CITY OF WINTER PARK PLANNING AND ZONING BOARD

Staff Report June 7, 2016

Staff Report June 7, 2016

Staff Report June 7, 2016

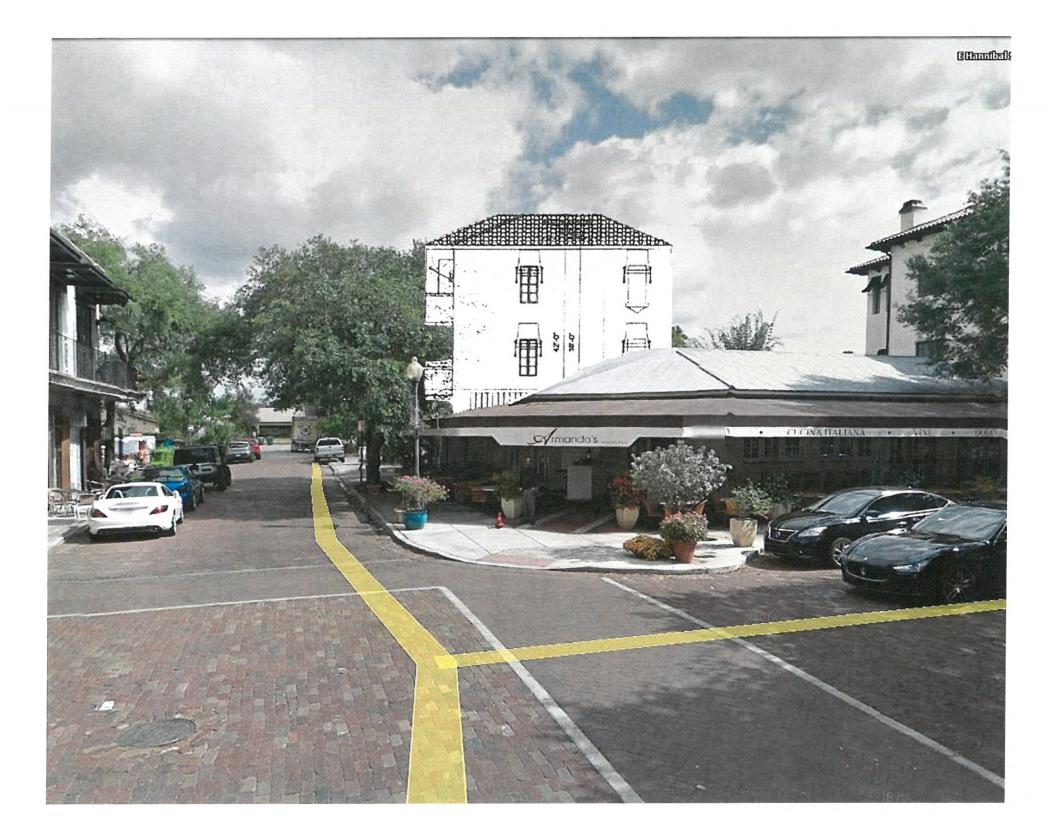
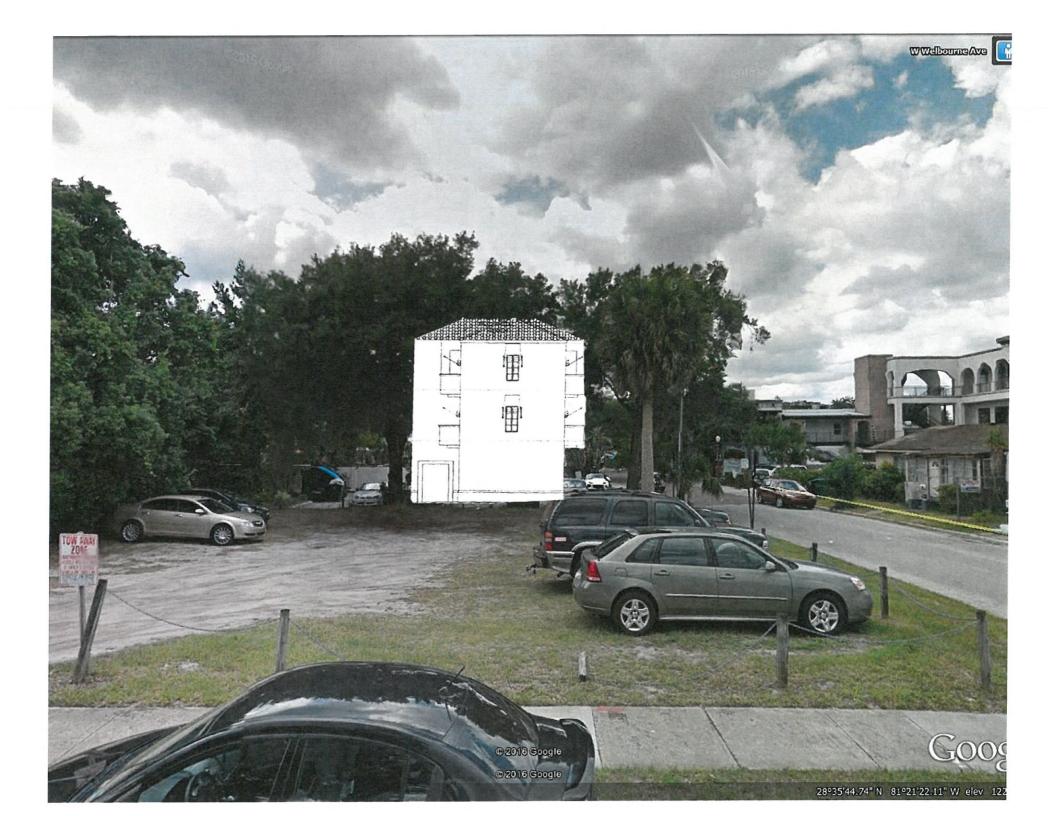
To the planning staff it seems unusual to build three stories, just to gain 840 feet of storage area. This is the equivalent of building a four car garage of storage space for a 2,600 square foot house.

It is difficult to assess the building's height and compatibility based on two dimensional elevations, as submitted, that are three inches in size. As a result, the staff has put together photographs of the adjacent properties with the applicants elevations superimposed in order to get a better perspective on the relative heights and compatibility. Again to the planning staff the three stories at this location is incompatible at the edge of residential zoning. That is consistent with the staff's recommendation in last month's agenda with the proposed three story, West Lyman townhouses that were also on the transitional edge of commercial to residential.

SITE DEVELOPMENT PLAN

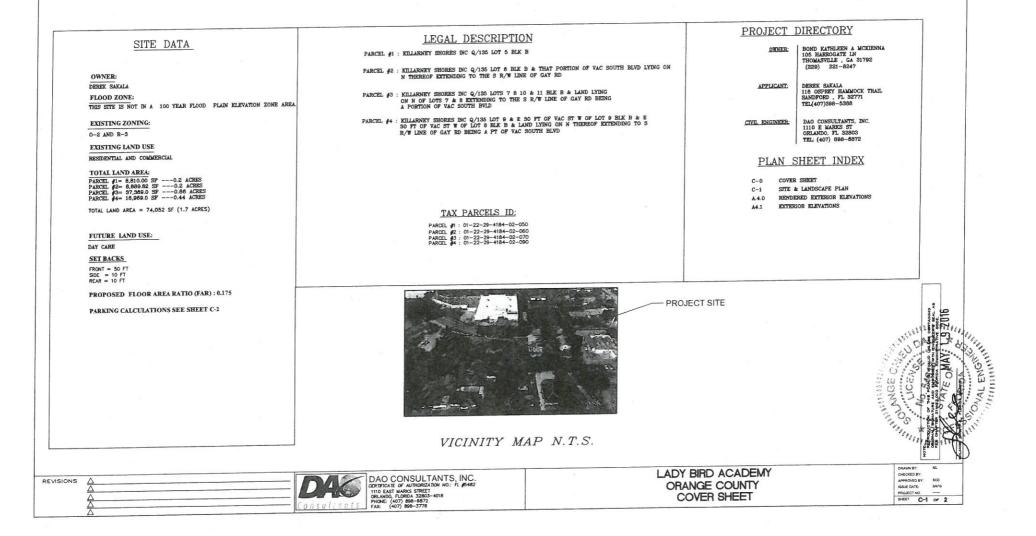
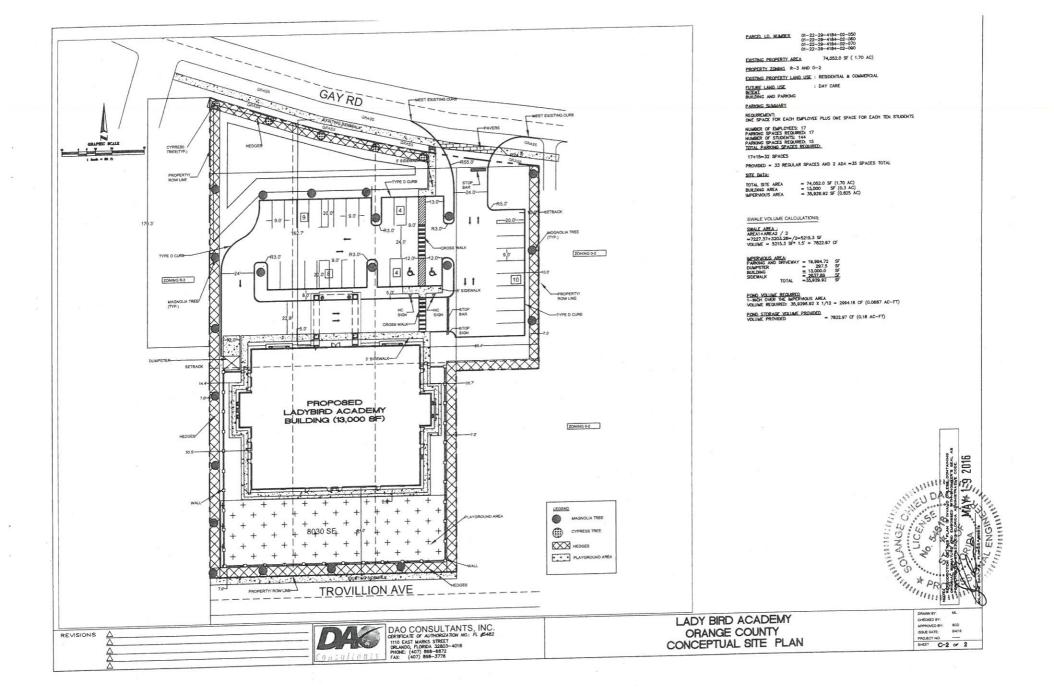
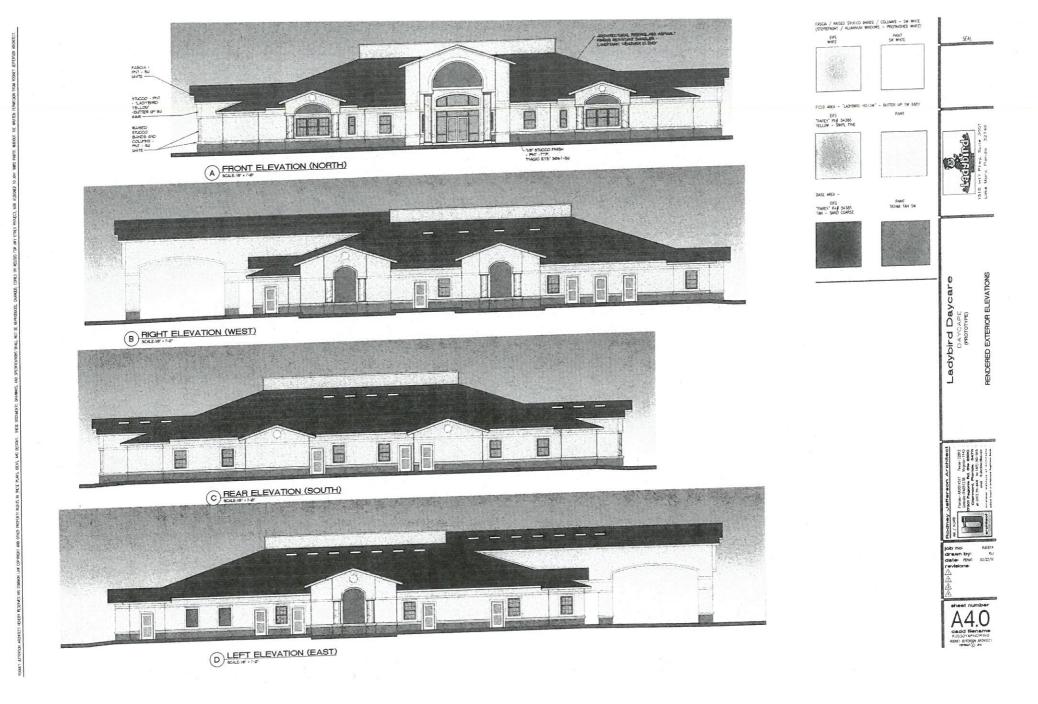
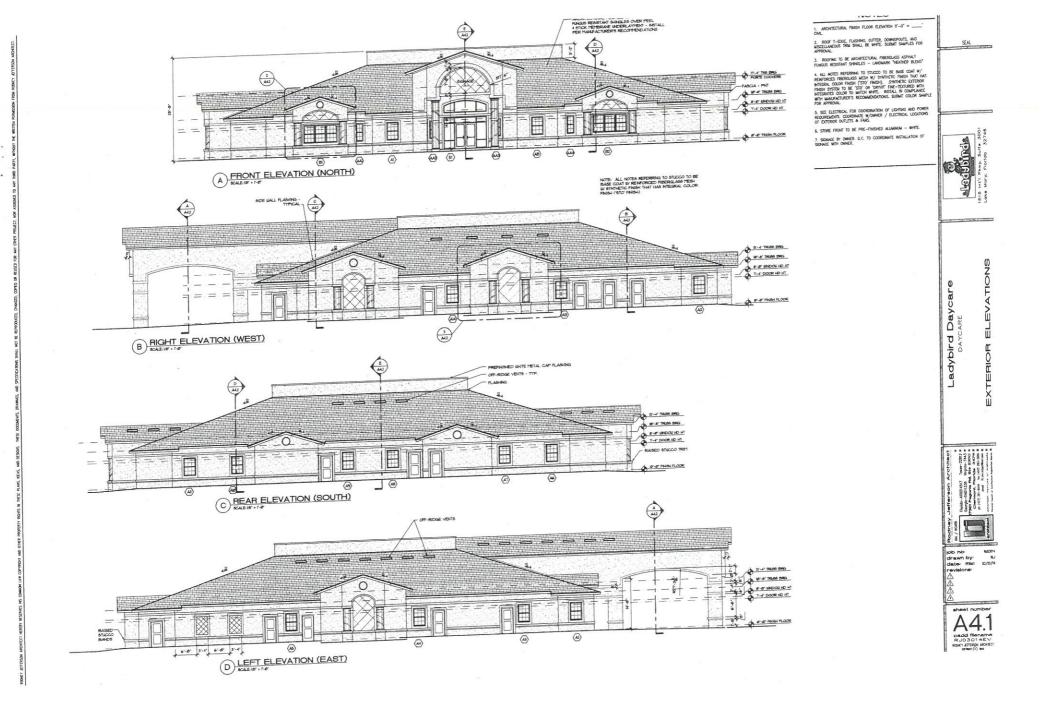
This application package is intended to provide the detail needed both for the "preliminary" and "final" conditional use approvals. Aside from the two items previously mentioned, (landscaping and wall design) which can be conditions of approval, everything else appears to have been provided.

- 1. The final design of the wall surrounding the playground and building shall be reviewed and approved by the P&Z Board.
- 2. The final landscape design including trees to be removed onsite be reviewed and approved by the P&Z Board.
